Comments from CRP PDR review 22/04/2022:

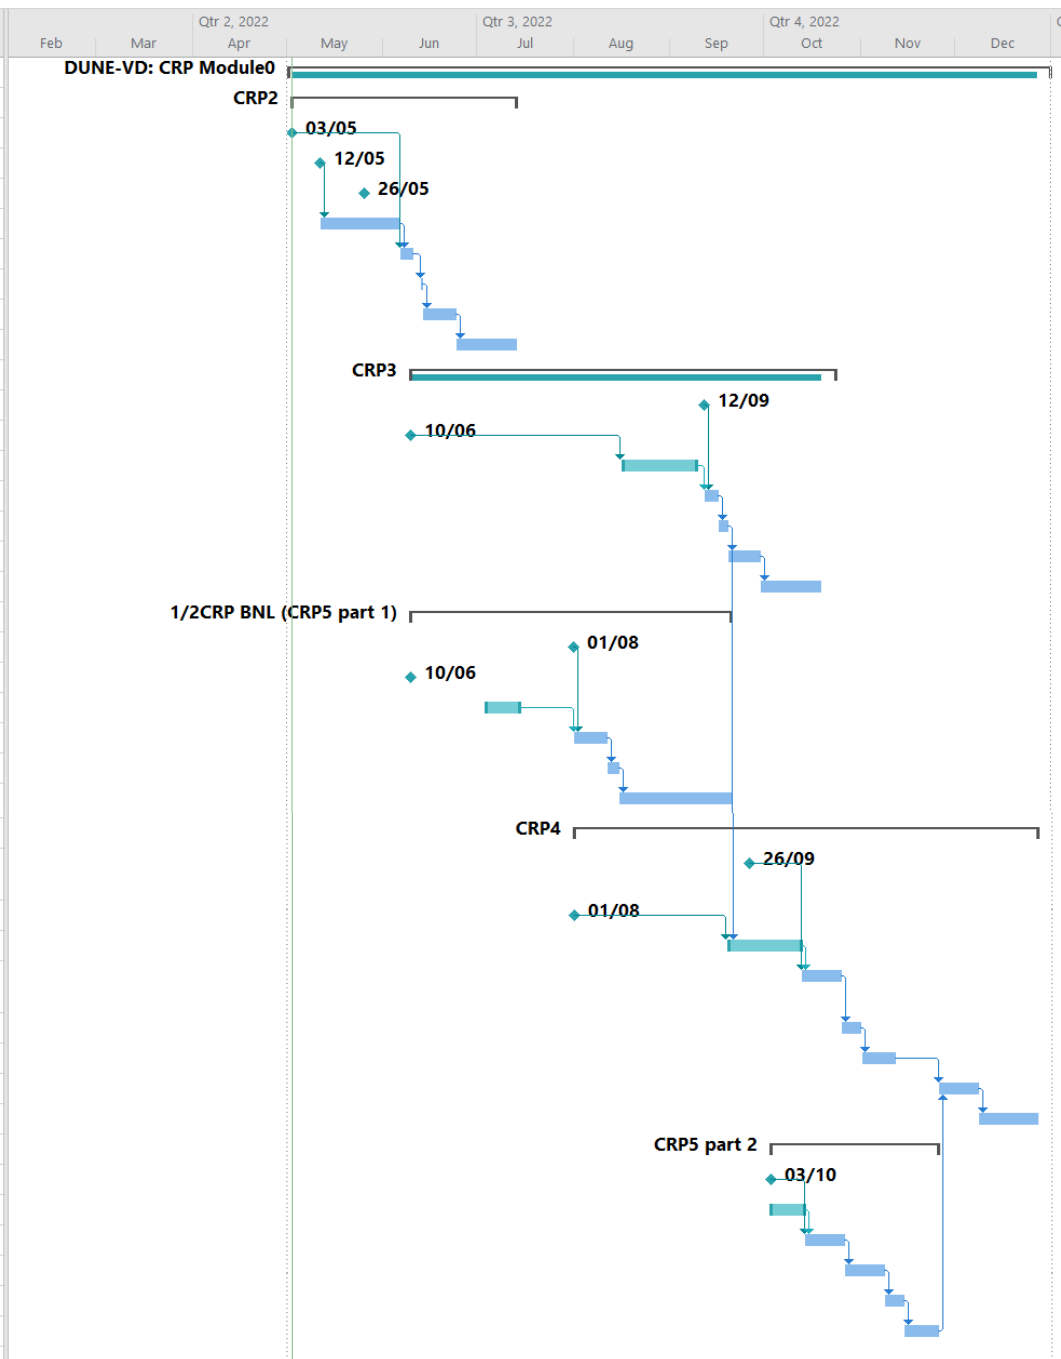
4) Slide 4: you mention two months margin for the components of CRP2; what safety margin is there for CRP 3-4-5 ?

Ideally, a GANTT chart would be useful to describe the planning of Module 0.

For CRP3 there is one month of margin to complete a cold box test before CRP4 arrives; for CRP4 the margin in 2022 is negligible but cold box test can be performed eventually early 2023 since it is a bottom CRP to be installed in Module 0 at the end

Next slide includes 1/2BNL CRP and CRP5

Task Name	Duration	Start	Finish
▲ DUNE-VD: CRP Module0	201,14 days	Mon 02/05/22	Sat 31/12/22
▲ CRP2	59 days	Tue 03/05/22	Wed 13/07/22
composite structure reception	0 days	Tue 03/05/22	Tue 03/05/22
anode reception batch 1	0 days	Thu 12/05/22	Thu 12/05/22
anode reception batch 2	0 days	Thu 26/05/22	Thu 26/05/22
anode/CRU assembly	20 days	Thu 12/05/22	Mon 06/06/22
CRP assembly	5 days	Mon 06/06/22	Fri 10/06/22
Transport to EHN1	1 day	Mon 13/06/22	Mon 13/06/22
Test in EHN1 faraday area	10 days	Mon 13/06/22	Fri 24/06/22
Cold box test	15 days	Fri 24/06/22	Wed 13/07/22
▲ CRP3	110,86 days	Fri 10/06/22	Sun 23/10/22
composite structure reception	0 days	Mon 12/09/22	Mon 12/09/22
anode reception Eltos batch 3	0 days	Fri 10/06/22	Fri 10/06/22
anode/CRU assembly	20 days	Wed 17/08/22	Fri 09/09/22
CRP assembly	5 days	Mon 12/09/22	Fri 16/09/22
Transport to EHN1	1 day	Fri 16/09/22	Mon 19/09/22
Test in EHN1 faraday area	10 days	Mon 19/09/22	Fri 30/09/22

Cold box test	15 days	Fri 30/09/22	Wed 19/10/22
▲ 1/2CRP BNL (CRP5 part 1)	83,14 days	Fri 10/06/22	Tue 20/09/22
composite structure reception	0 days	Mon 01/08/22	Mon 01/08/22
anode reception Eltos batch 3	0 days	Fri 10/06/22	Fri 10/06/22
anode/CRU assembly	10 days	Mon 04/07/22	Thu 14/07/22
send anodes and frame to BNL	10 days	Mon 01/08/22	Thu 11/08/22
1/2CRP assembly	2 days	Thu 11/08/22	Mon 15/08/22
BDE integration tests at BNL	30 days	Mon 15/08/22	Tue 20/09/22
▲ CRP4	121,43 days	Mon 01/08/22	Tue 27/12/22
composite structure reception at CERN	0 days	Mon 26/09/22	Mon 26/09/22
anode reception batch 1 NCAB	0 days	Mon 01/08/22	Mon 01/08/22
anode/CRU assembly	20 days	Mon 19/09/22	Wed 12/10/22
send anodes and composite to US	10 days	Wed 12/10/22	Tue 25/10/22
CRP assembly	5 days	Tue 25/10/22	Mon 31/10/22
Send from US to EHN1	10 days	Tue 01/11/22	Fri 11/11/22
Test in EHN1 faraday area	10 days	Fri 25/11/22	Thu 08/12/22

Cold box test	15 days	Thu 08/12/22	Tue 27/12/22
▲ CRP5 part 2	45 days	Mon 03/10/22	Fri 25/11/22
composite structure reception	0 days	Mon 03/10/22	Mon 03/10/22
anode/CRU assembly	10 days	Mon 03/10/22	Thu 13/10/22
send anodes and frame to Yale	10 days	Thu 13/10/22	Wed 26/10/22
1/2CRP assembly and test	10 days	Wed 26/10/22	Tue 08/11/22
CRP5 complete assembly	5 days	Tue 08/11/22	Mon 14/11/22
Send from US to EHN1	10 days	Mon 14/11/22	Fri 25/11/22
